LEVEL 2 — OVERALL FLOOR PLAN (REV H)

PROJECT Hazel Green Regional Athletic Complex Trojan Horse Arena · Hazel Green area, Madison County, Alabama (site TBD, D-006)	PHASE PHASE 2	SHEET TITLE OVERALL FLOOR PLAN LEVEL 2 · BLOCK PLAN	SCALE 1" = 40'-0"	DATE October 2026	REV H	DRAWN BY Drawn by KEYSTONE (AI) for Shane Brazelton	SHEET P2-A-102
--	-------------------------	---	---------------------------------------	---------------------------------------	-----------------	---	------------------------------

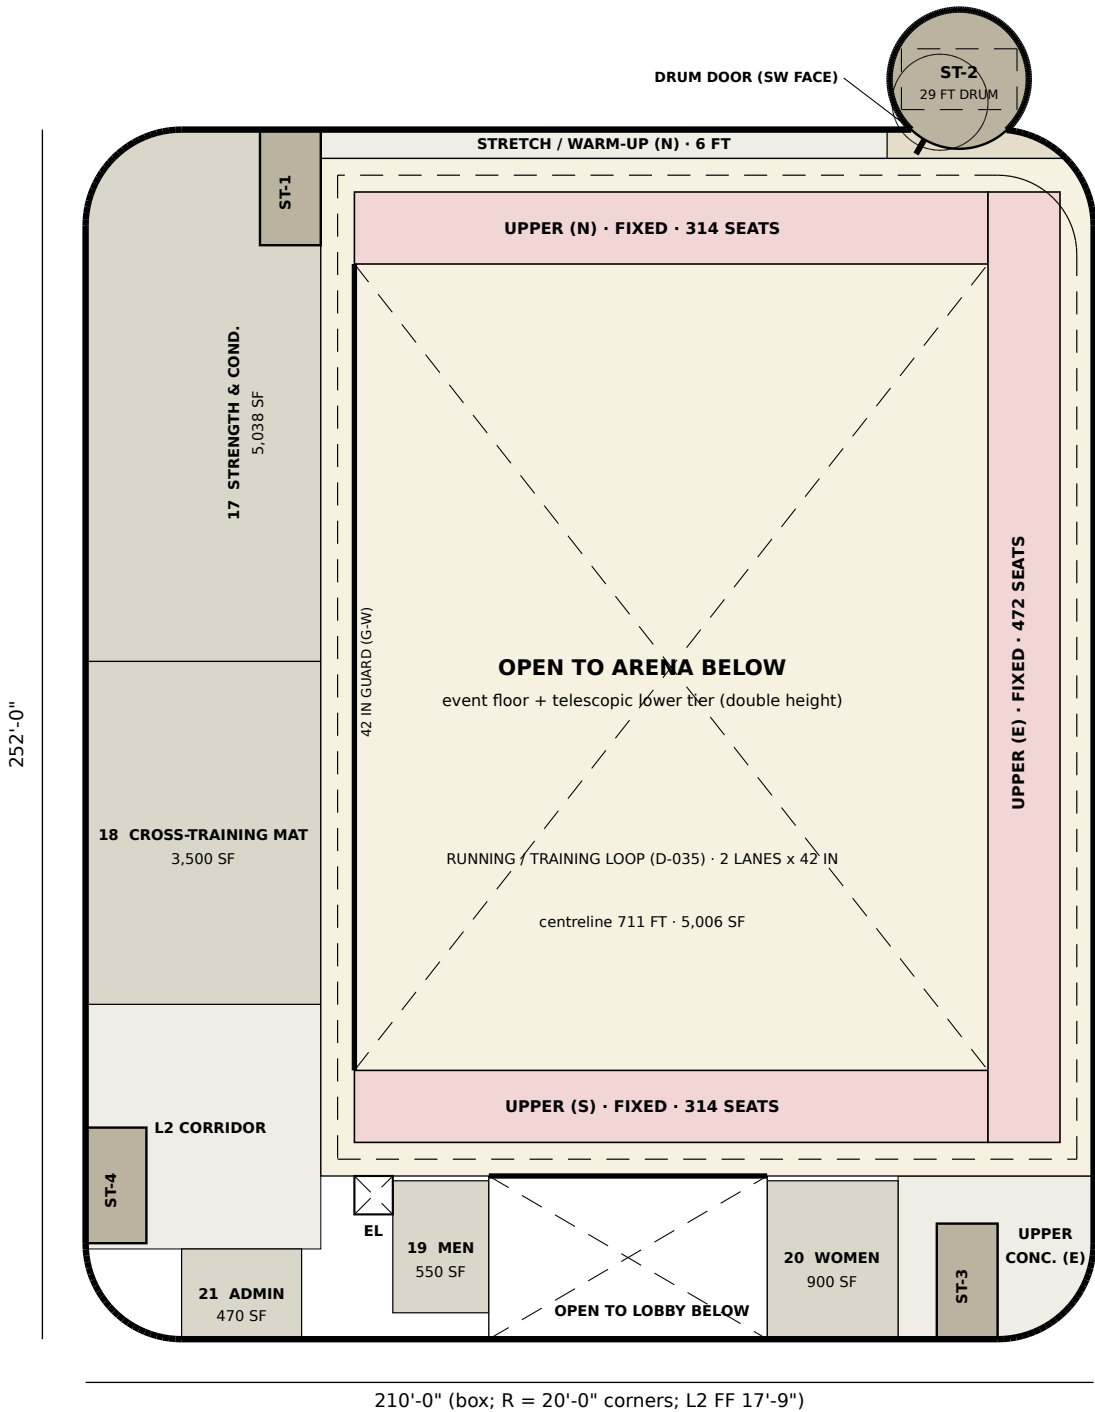
CHANGES FROM REV G (all ASSUMED)

- ST-2: 29 ft drum centred (182, 262.5), same as Level 1; holds the 12.67 x 24.08 ft 76 in stair (dashed) with 0.49 ft spare on the diagonal. +341 SF on this level.
- North stretch strip now ends at x 167 (was 168); drum door on the SW face at (174.8, 249.9), opening into the strip landing, not onto the loop.
- Drum south edge y 248.0: clear of the loop's north edge (y 246) by 2.0 ft; the loop, its R 13 ft NE corner and the upper tiers do not change.
